Board of Adjustment Hearing Application - Entry #381

Request for Variance – Rear Deck Setback

REAR PORCH ADDITION FOR:
HILLEBRANDT RESIDENCE
2106 WILSON RIDGE LANE
CLARKSON VALLEY, MO 63005

To: Chairman & Members of the Board of Adjustment
From: Paul Mercurio, Building Commissioner
cc: Sue McNamara, Mayor
Date: October 8, 2026
Re: Board of Adjustment Variance Request – 2106 Wilson Ridge Lane

SITE PLAN

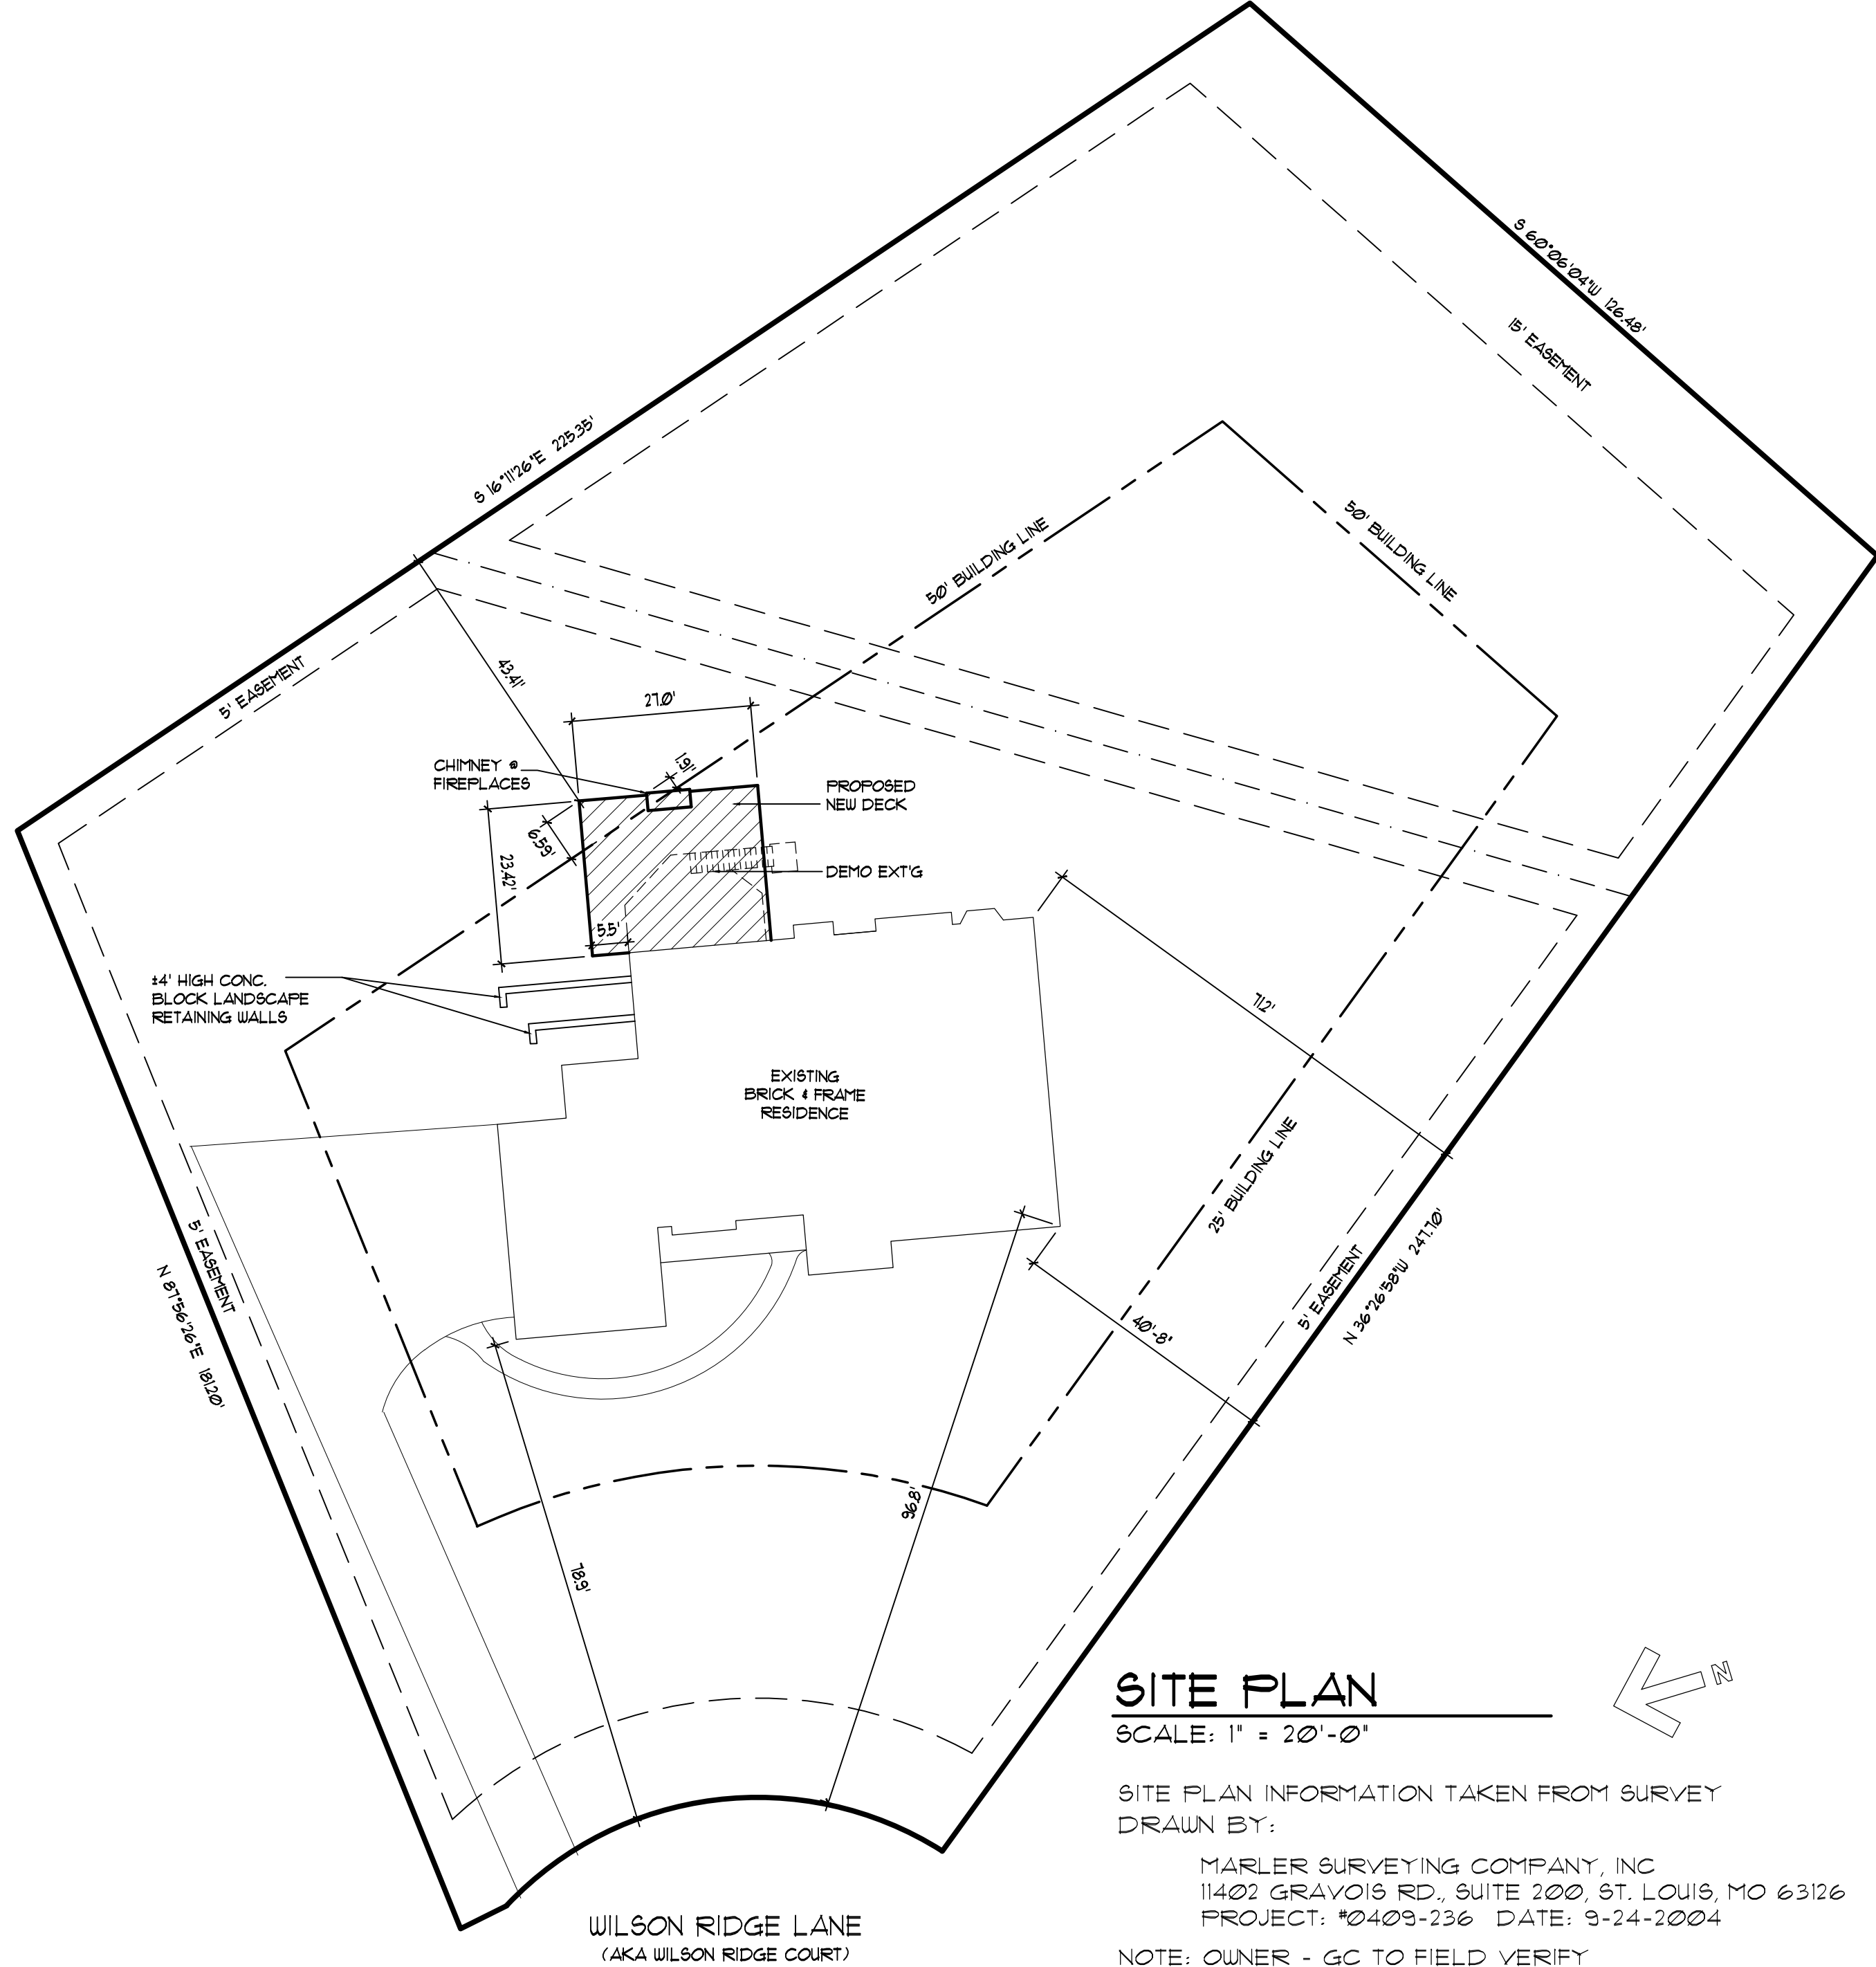
I have reviewed the information submitted for the proposed deck replacement project. Based on that review, the proposed new project does not meet Clarkson Valley zoning requirements for the rear 50-foot rear (East) building line setbacks. Therefore, I cannot continue my review and must formally deny the application unless and until a variance is granted by the Clarkson Valley Board of Adjustment (CVBOA). The documents you submitted appear to include the details needed for a CVBOA hearing if you choose to proceed. Please contact City staff for information about the CVBOA application process; they have been copied on this email. On a separate note, please have your design professional administer a seal to the submitted documents.

- On the north-east side of the property the structure encroaches six and one half feet (6.5') into the rear 50' setback.
- The structure then travels east, approximately thirteen feet (13') tapering down to zero feet (0) at the chimney fireplace.

The proposed structure at the highest point (chimney) is approximately 23 feet.
